Memorandum

To:	Ralph Henderson (Boffa Miskell)
From:	Jeremy Trevathan (Acoustic Engineering Services)
File Reference:	AC23320 - 05 - R1
Date:	Tuesday, 14 October 2025
Project:	Contact Energy Southland Wind Farm Fast-Track Consultation Comments on noise related matters
Pages:	6
Meeting	Telephone Memorandum File Note

Figure 1 - Oversize delivery transport routes (reproduced from Part G - Technical Report Maps)

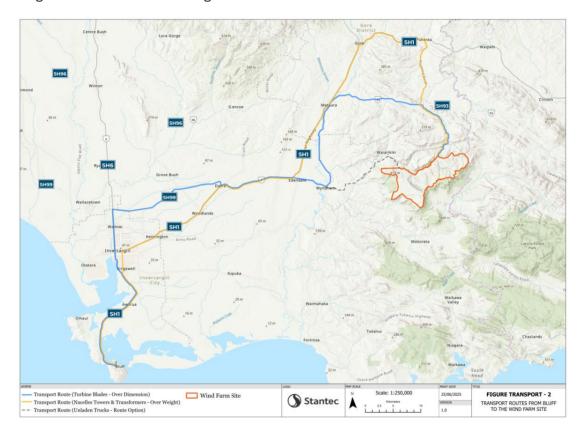
- I reiterate my previous concerns regarding noise from transport of the wind turbine and electrical components to the site. From a review of the Transport Assessment it is likely that this will require 662 deliveries of over size components over a period of 180 days, which due to various operational constraints will result in the oversize convoys passing through both urban and rural residential settings during the night-time period. While there is not a detailed breakdown of the proposed transportation schedule available at this stage, a worst-case scenario could feasibly result in night-time deliveries every night for a period of six months. MDA have predicted noise levels in the order of 60 70 dB L_{Aeq} for dwellings within 10 20 metres of the convoy's path. As shown in figure 1 below the overall transport path taken by the oversize night-time deliveries is in the order of 110 130 km and passes through Invercargill along with several townships. This results in a large number of both urban and rural dwellings that would be expected to experience elevated noise levels of this magnitude for each of the 662 night-time deliveries.

MDA have concluded that this activity would result in temporary minor noise effects as night-time heavy vehicle movements are an anticipated noise source in the area, and the project would not significantly add to the traffic volumes at most receivers. From my understanding the transportation methods required to move wind turbine components are significantly different to standard heavy vehicle movements, as the trucks need to travel slowly in built up areas or sections of road with corners or roundabouts so that tracking does not result in damage to the equipment or nearby infrastructure. Pilot cars and other support vehicles such as crane trucks or trucks with basket lifts are also required during the transportation. Due to the oversize nature of the components, delivery often requires temporary removal or relocation of street signage, lamp posts, power lines and the like, all of which increases the amount of time the noise is present near potential receivers, as well as adding new noise sources. This can in part be conducted prior to the arrival of the delivery vehicles, but often can only be assessed and enacted on site. Overall I still have concerns regarding the noise

effects of this portion of the activity, and recommend that further clarification of the delivery schedule and noise mitigation processes is provided.
